# Product Change Notification (PCN)

PCN #: 7B-2022

DATE: 10<sup>th</sup> August 2022

## 4 ANTICIPATED IMPACT OF THE CHANGE:

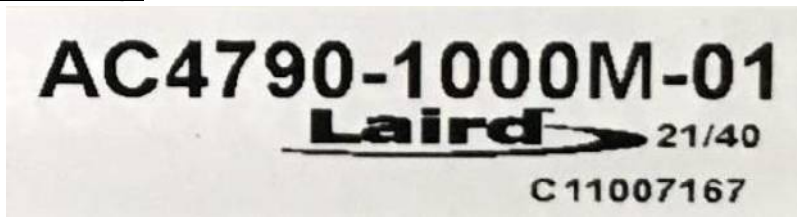
- Regulatory Test and resubmission for Permissive Class 2 change under the same FCC and ISED IDs
- Updated labelling
- RF performance maintained from prior hardware revisions
- No software changes.
- No form, fit or function changes.
